**[Docket No. FAA-2007-28688; Directorate Identifier 2005-SW-21-AD; Amendment 39-15312; AD 2007-26-10]**

#### **Airworthiness Directives; Bell Helicopter Textron Canada Model 430 Helicopters**

**ACTION:** Final rule.

**Figure 1**

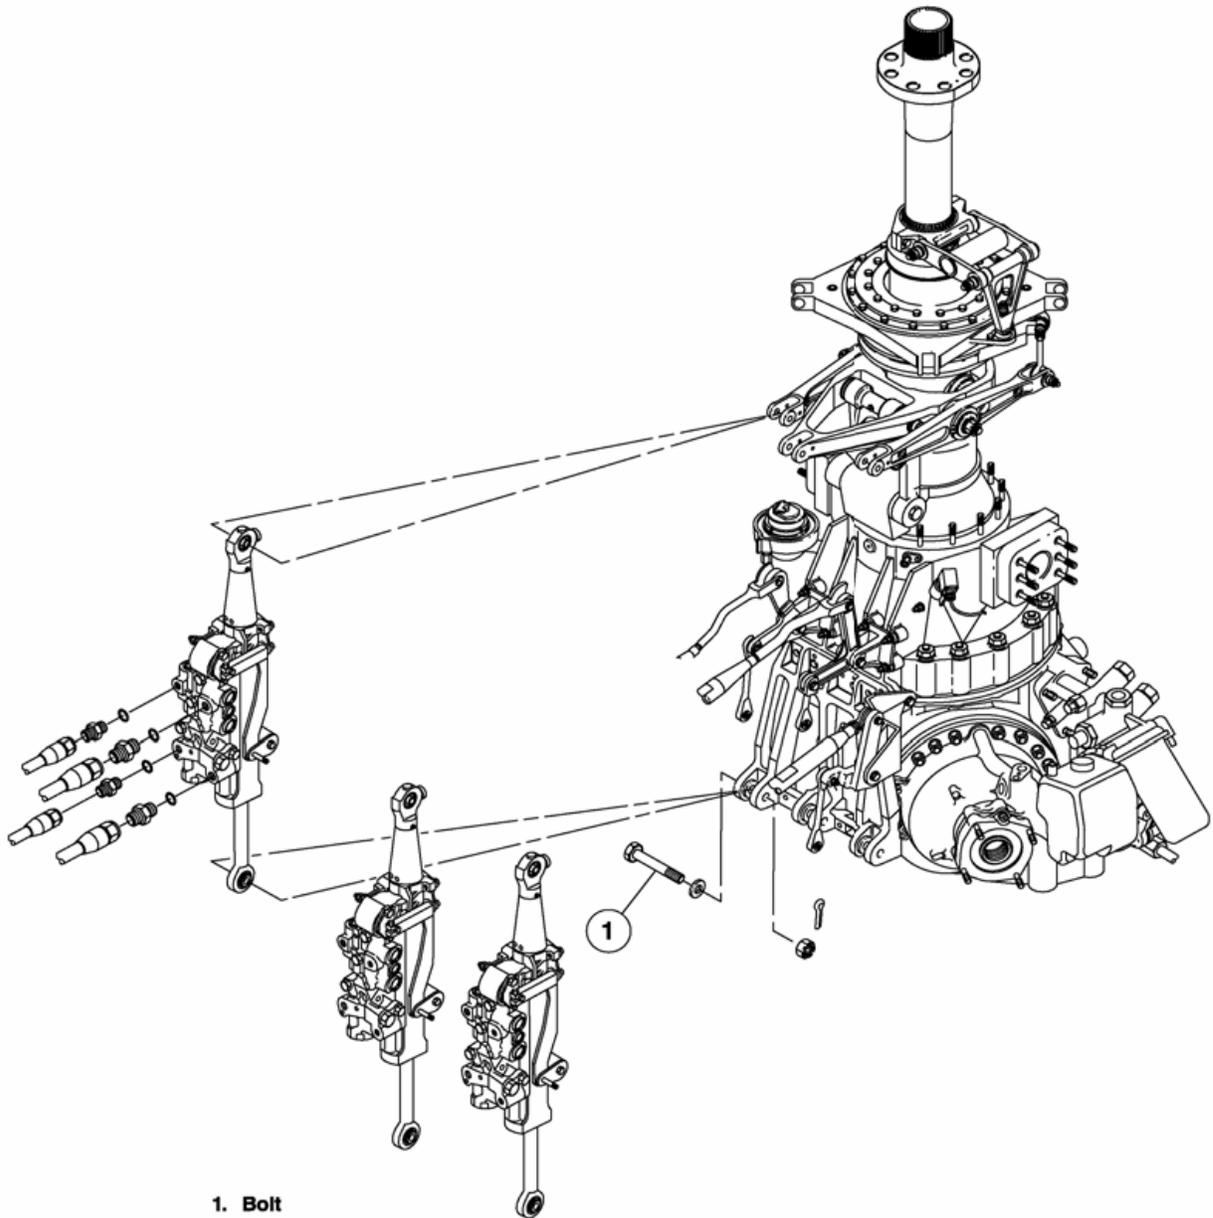
(a) Within 150 hours time-in-service (TIS), replace all three affected bolts, as depicted for one of these bolts in Figure 1 of this AD, with airworthy, zero-time bolts, P/N 50-047C8-31.

Note 1: Only the right servo lower attach bolt (1) is shown. The collective and left cyclic servo lower attach bolts are also to be replaced. (This AD does not apply to the same part-numbered bolts at the upper end of each servo.)

(b) This AD revises the Airworthiness Limitations section of the maintenance manual by establishing a retirement life of 5000 hours TIS for each bolt.

(c) Record a 5000-hour TIS life limit for each bolt on the component history card or equivalent record.
